Re: Addendum Number 2 to our Environmental Impact Study for Muskoka Royale College, Responding to the July 14, 2019 Peer Review Comments; Our File 3517

Table 1. Peer Review Response

Table 1. Peer Review Response.

Figure A. Three vernal pool locations observed on June 6, 2018 in CF1.

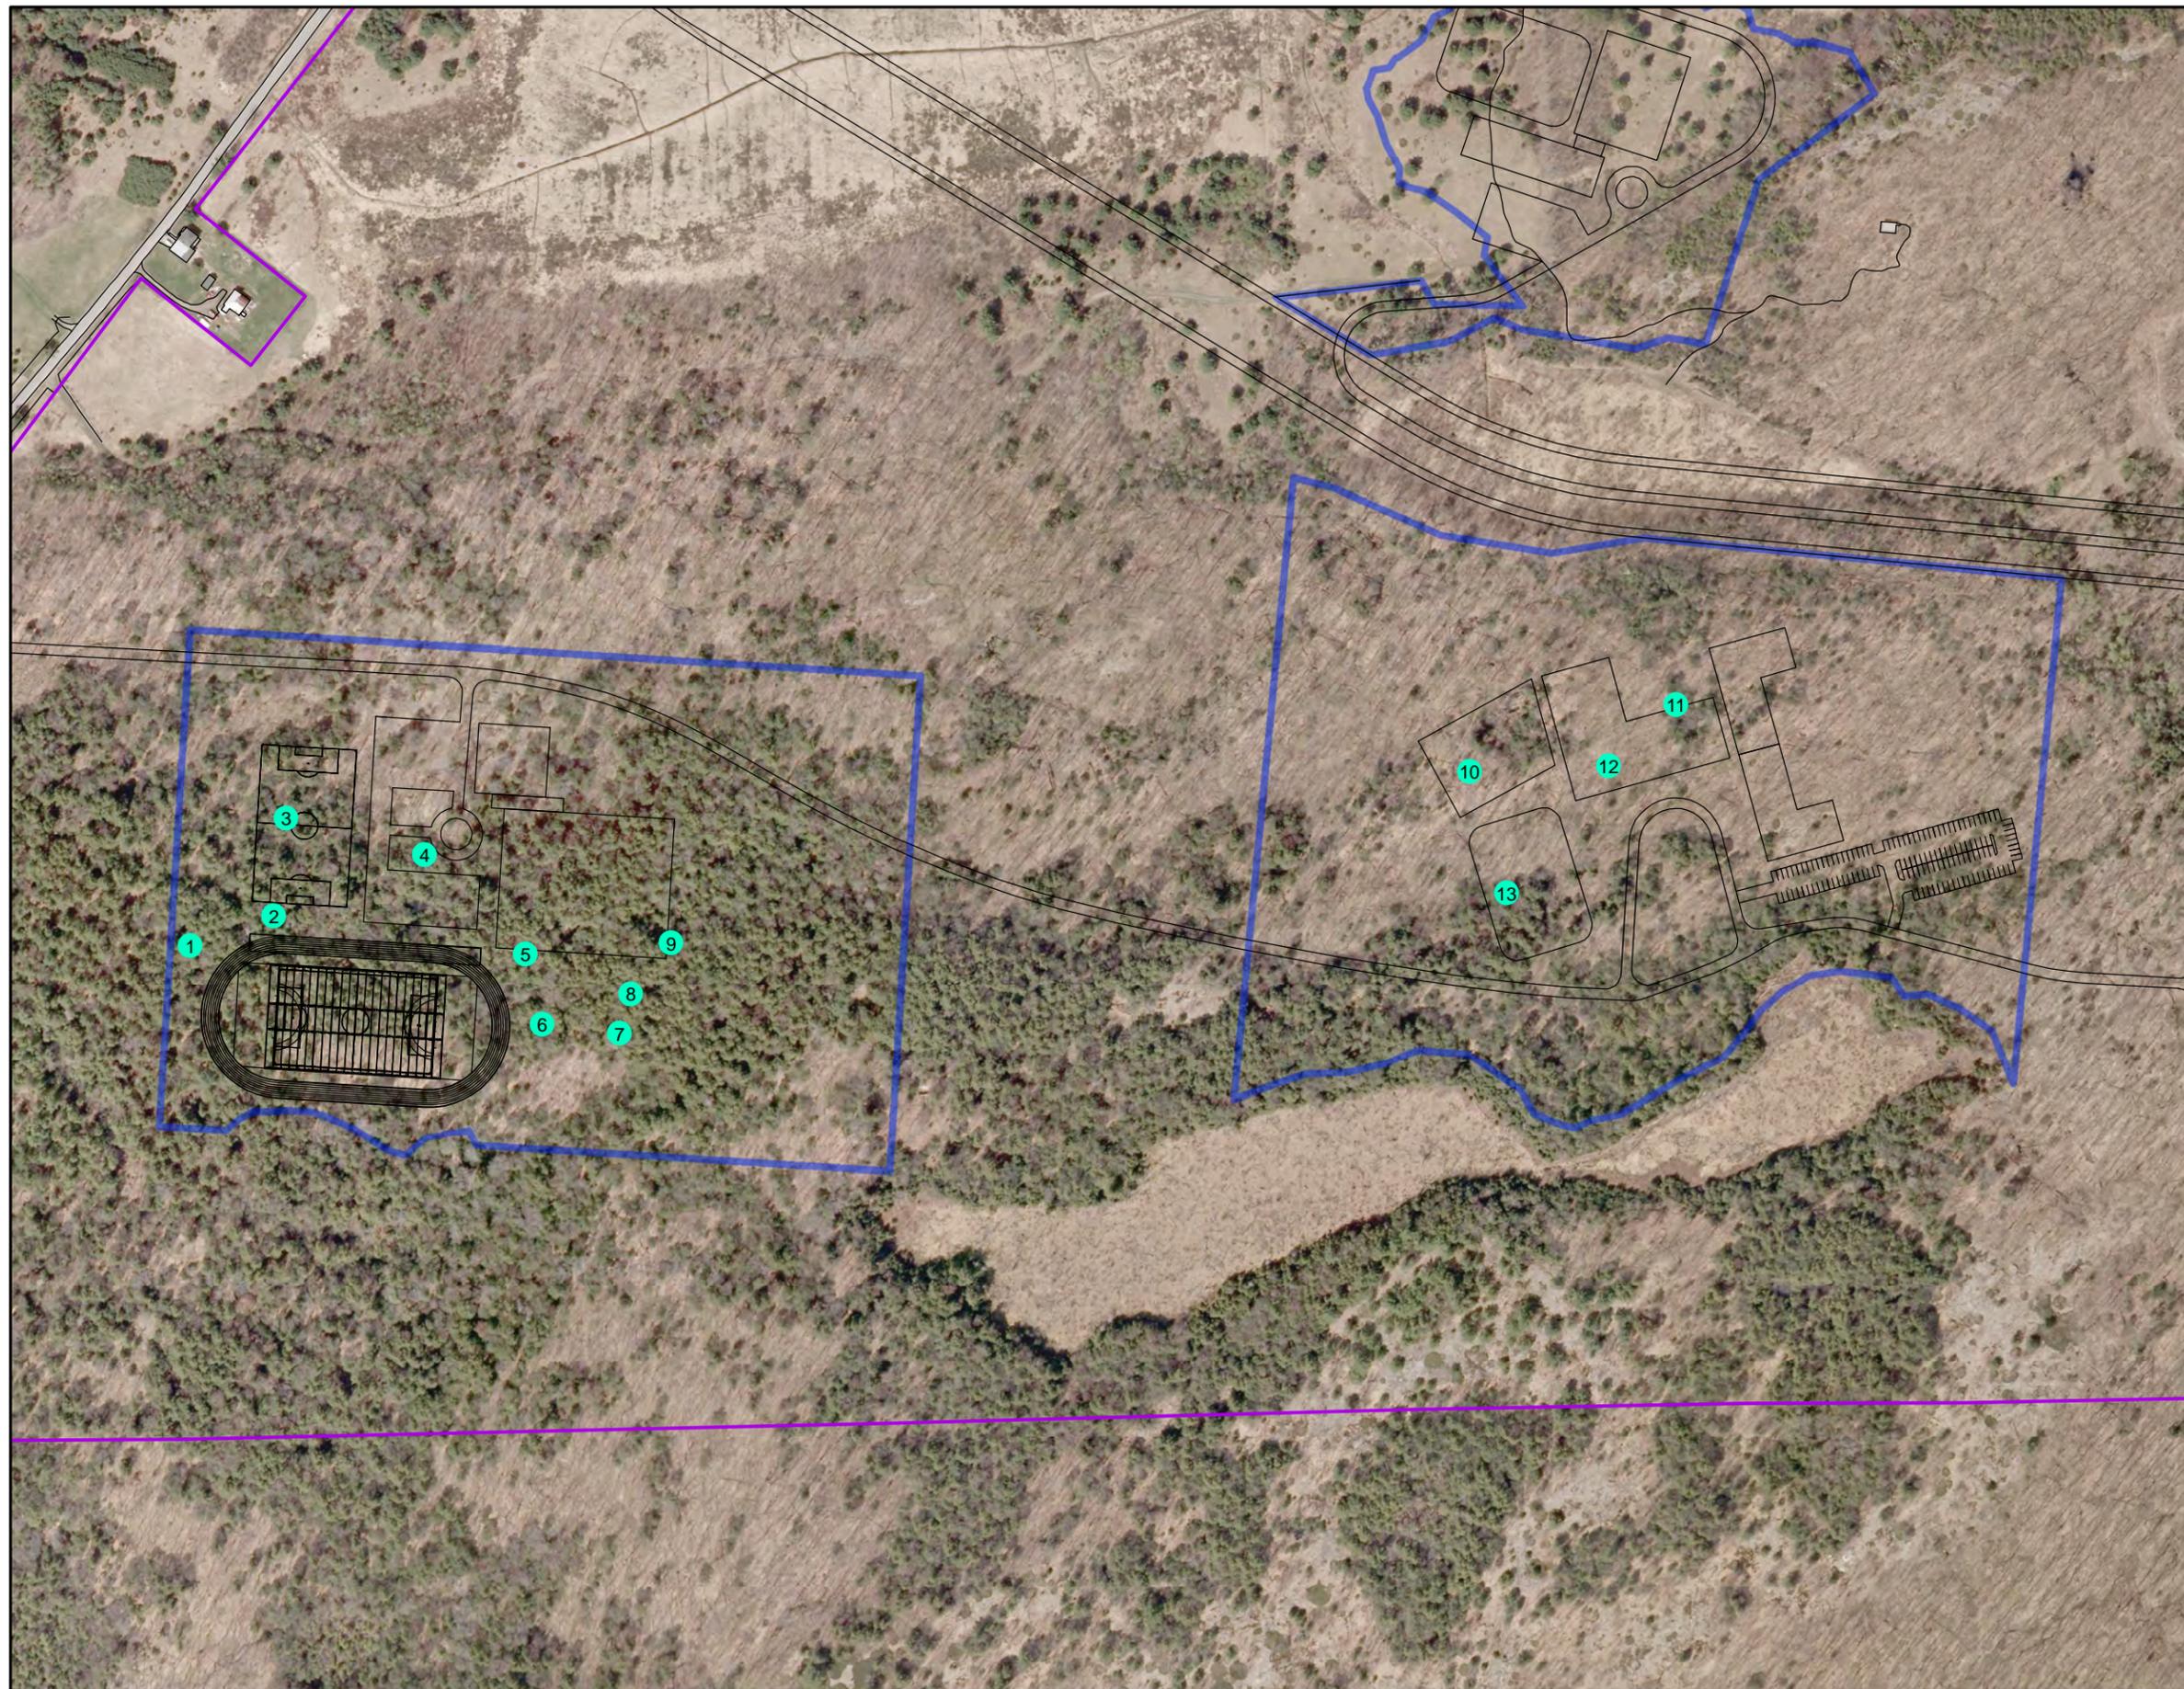
| HESL Peer Review Recommendation # | Updated Recommendation From HESL | MNAL Response | Additional Comments from HESL |
|--|--|--|--------------------------------------|
| 12 | We recommend that the results of the additional 2019 vernal pool surveys be included in an updated version of the EIS. Any vernal pools that are identified in these surveys as amphibian breeding habitat should be located outside the development footprint, with at least a 30 m buffer around them. | The results of the additional 2019 surveys of the vernal pools is provided in Appendix D . No amphibians were heard in these features in 2018. Despite the very wet spring conditions in 2019, none were large enough to qualify as Significant Wildlife Habitat for woodland amphibians. None of the vernal pools had egg masses or tadpoles in them in 2019. | |

The vernal pools and small wetland inclusion areas in Precincts A and B were surveyed on the evening of May 29, 2018 and no calling amphibians were recorded. There were three vernal pools that were assessed on June 6, 2018 in the Coniferous Forest (CF1) community and are shown on the attached **Figure A**. During the June 6, 2018 day time survey, there were no amphibians, tadpoles or eggs observed in those vernal pools. The water was not deep enough for amphibians to use the pools for breeding (**Photo 1 and 2**). These results indicate that those identified vernal pools do not provide breeding amphibian habitat.

At the request of the peer reviewer, additional surveys were completed on June 25, 2019 survey during the day time. The timing of this visit was appropriate in that it was before the eggs of early breeding amphibians would have hatched out or when their tadpoles would have reached a development stage where they were no longer dependent on these pools. There were a total of 13 vernal pools identified in Precincts A and B. A detailed description and characterization of each vernal pool is provided in **Table 1**, with locations shown on **Figure B**. All of the surveyed vernal pools are smaller than the identified size criterion in the Significant

**APPENDIX F – SUPPLEMENTARY INFORMATION ON THE
DEER YARD AS A WHOLE, AND DISCUSSION
OF POTENTIAL LOSSES IN FUNCTION,
INCLUDING CUMULATIVE IMPACTS OF
OTHER POTENTIAL DEVELOPMENT
WITHIN IT**

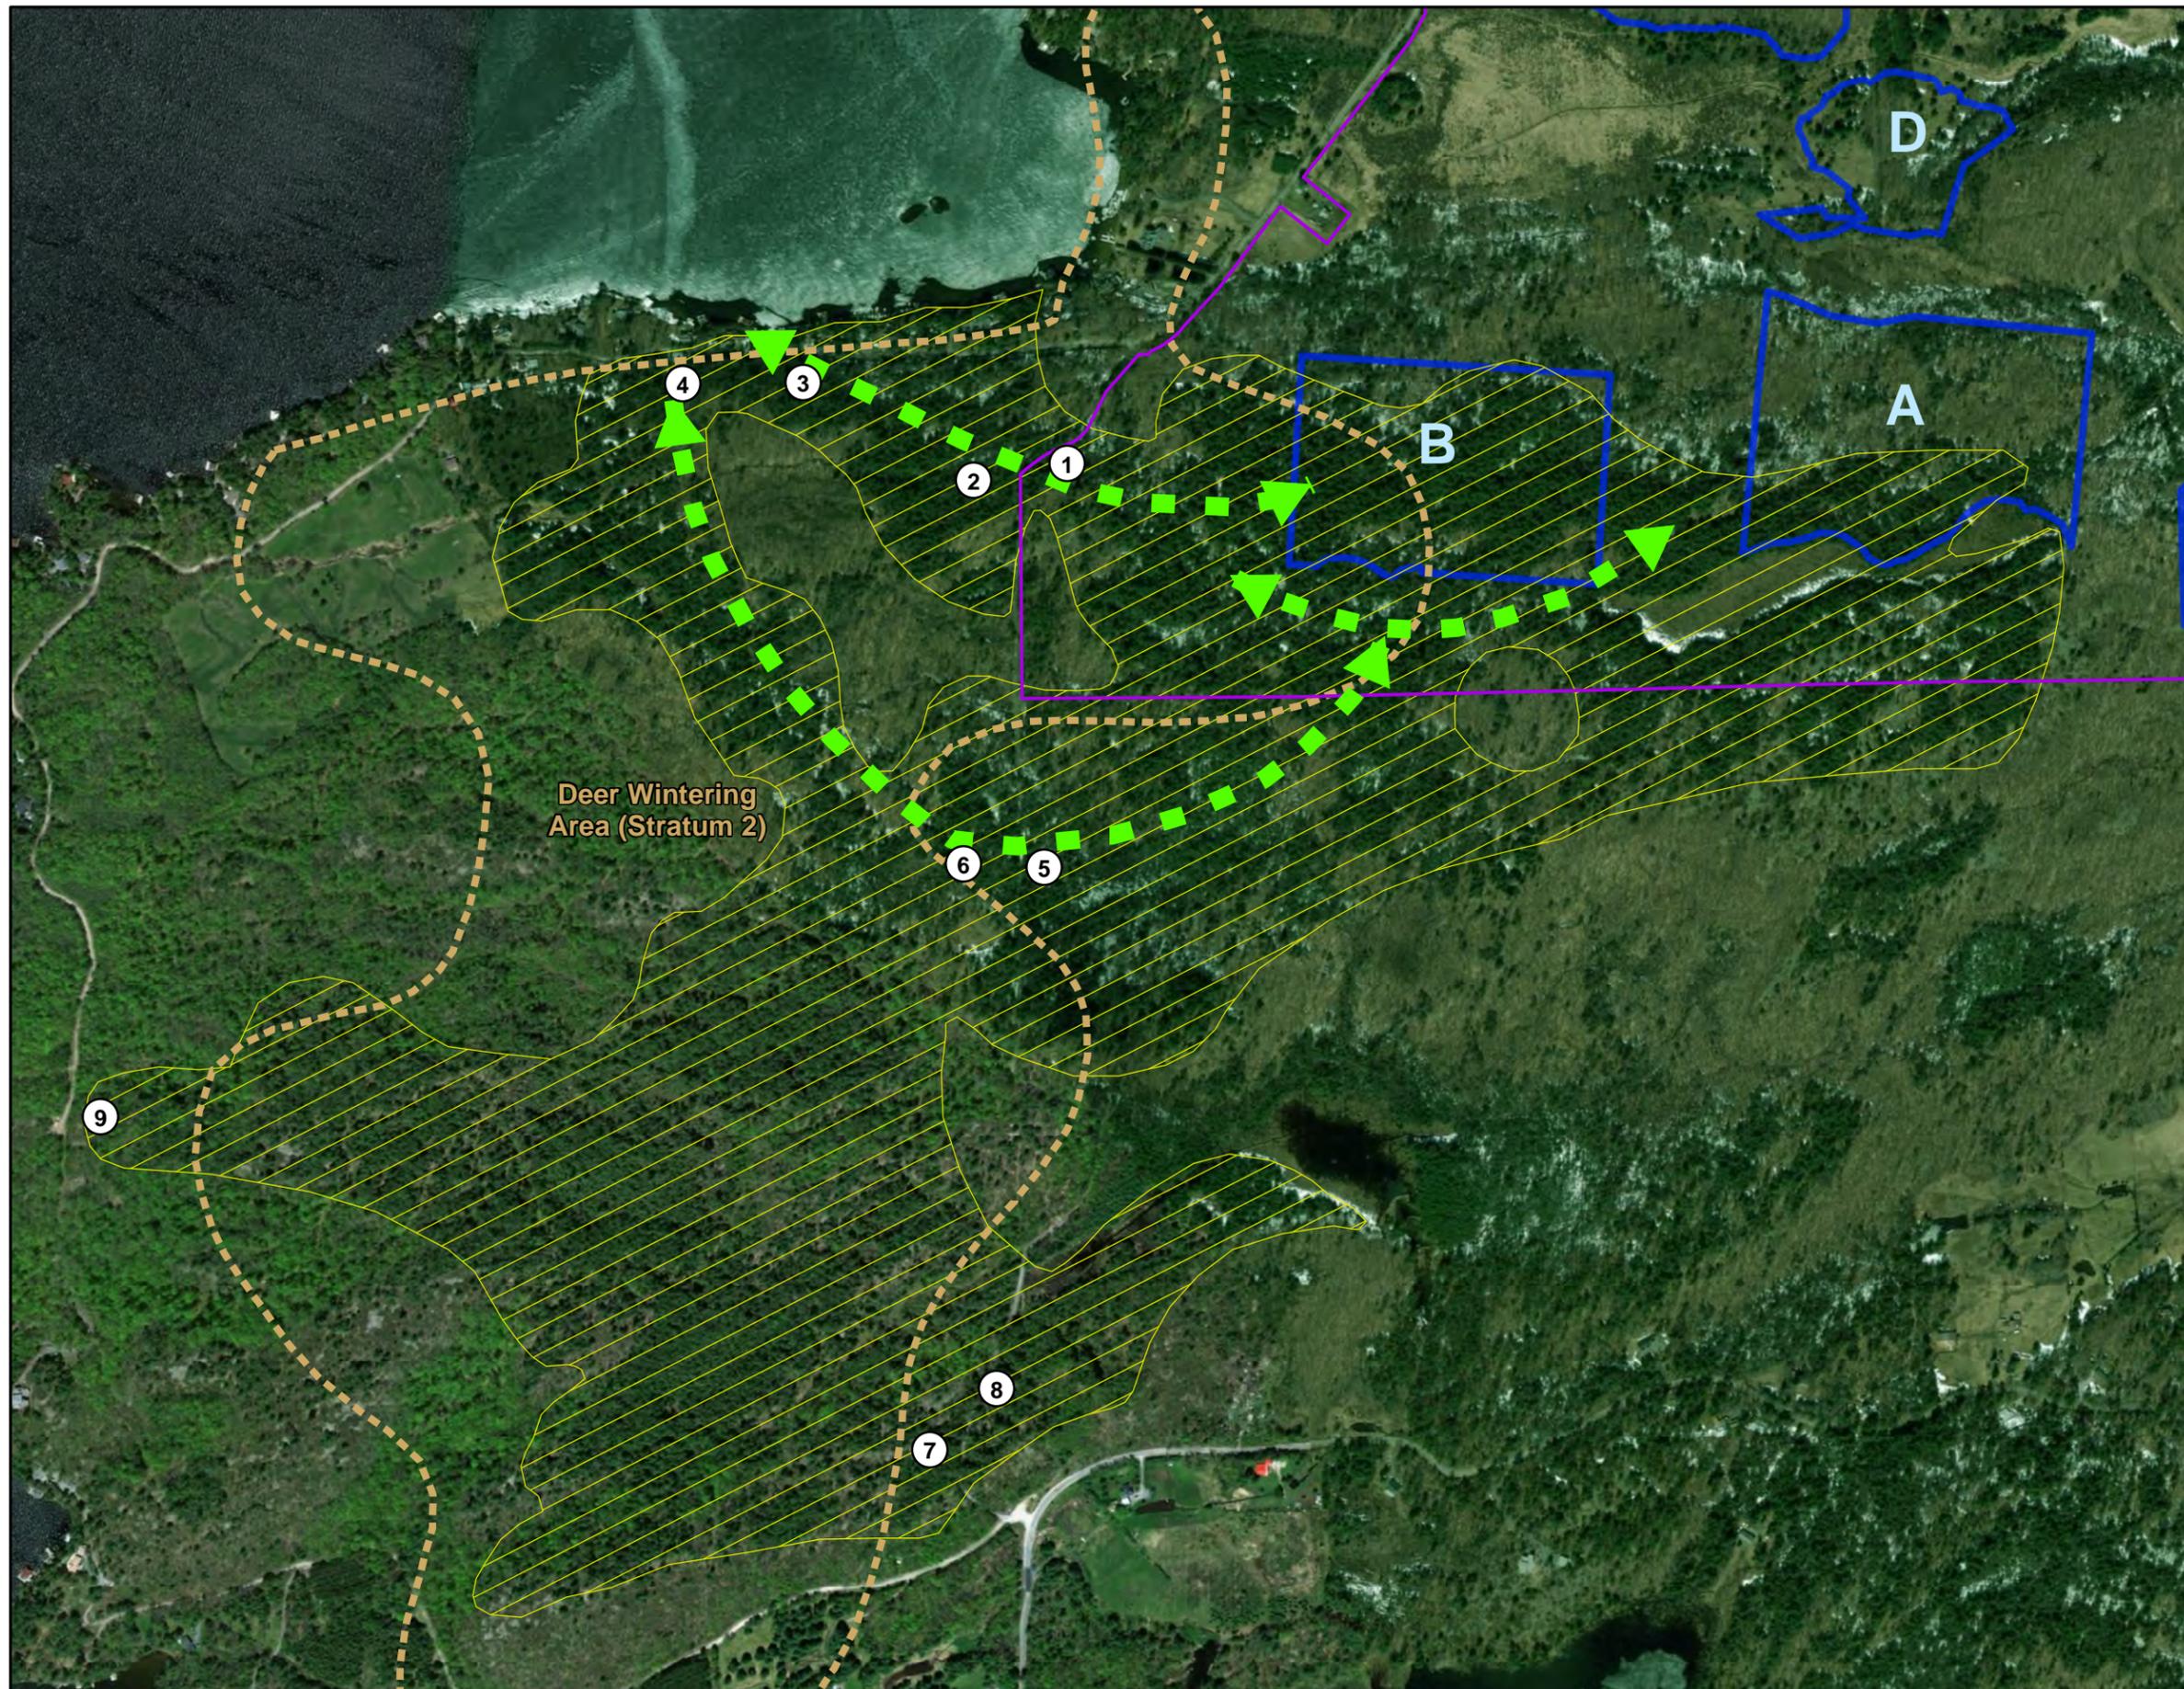
| HESL Peer Review Recommendation # | Updated Recommendation From HESL | MNAL Response | Additional Comments from HESL |
|--|--|--|--------------------------------------|
| 17 | Please discuss the quality of the remaining MNRF identified Stratum 2 deer wintering area that occurs outside the property and assess its condition in terms of cumulative effects that might exist, such as other development pressures, road fragmentation etc. | Supplementary information on the deer yard as a whole is provided in Appendix F . This demonstrates that there are substantial areas of good winter cover outside of the portion of this deer yard within the subject property, and that access to retained areas of good winter cover within the subject property will remain viable upon development. The Site Plan Control process provides an opportunity to confirm that access to retained areas of good winter cover within the property is being maintained. As such there are no warrants for additional winter deer surveys. The District of Muskoka confirmed in the meeting of May 17, 2019 that they do not ever request more than a single year of surveying for winter deer cover, notwithstanding MNRF's advice in their "Deer Habitat Assessment 101", which is only a guidance document and has no official status in relation to the assessment of significant wildlife habitat. | |

MNRF deer habitat mapping is quite broad based, and often includes areas of better and poorer quality within its boundaries. Further, areas of good quality habitat may well extend beyond its identified boundaries. With that in mind, and prior to completing additional survey work, ecologists examined aerial photography for the lands within and adjacent to MNRF's mapped deer yard to identify areas of higher quality conifer cover in order to determine which areas within and adjacent to the Muskoka Royale property appeared most suitable as winter cover for deer. The results of that assessment, as confirmed through targeted ground truthing, are provided in **Figure A**, with the yellow-hatched area providing our interpretation, based on aerial photography, of the areas of best quality cover, superimposed over MNRF's identified deer yard, outlined in the dashed orange line. This mapping demonstrates, as was discussed in the EIS, that areas of good conifer cover that could support deer overwintering extend beyond the MNRF-identified deer yard within the subject property; the same is also true within some of the surrounding landscape.

On July 22 and 26, 2019, ecologists surveyed areas that were accessible along roadways within this area for potential deer wintering habitat. This included 9 new stations in and adjacent to the MNRF-identified deer yard, all in areas which were identified as having good potential cover characteristic based on our aerial photo interpretation exercise (**Figure A**). The roadside survey included an assessment of six areas along Stagecoach Road (Stations #1, 2, 5, 6, 7 and 8) and three areas along Stephens Bay Road (Stations #3, 4 and 9), as shown on **Figure A**. The information recorded at each station included the species composition (plant species and cover), evidence of deer activity and a general ranking of habitat quality. That information is summarized in **Table 1**. **Photographs 1 – 9** provide representative views from these visits.

This additional survey illustrates that there are many areas of high quality deer habitat within or adjacent to the MNRF deer yard which are outside of Development Precincts A and B of the Muskoka Royale property. Further, it shows that the locations of those precincts does not interfere with deer movement through areas of good quality cover that is to be fully retained within and adjacent to the Muskoka Royale property. In this regard, the green dashed lines on **Figure 1** illustrate how deer movement opportunities into and out of this property will be maintained, and how deer can continue to move between the property and the shoreline of Lake Muskoka, as they commonly do in either foraging trips or in seeking out shelter.
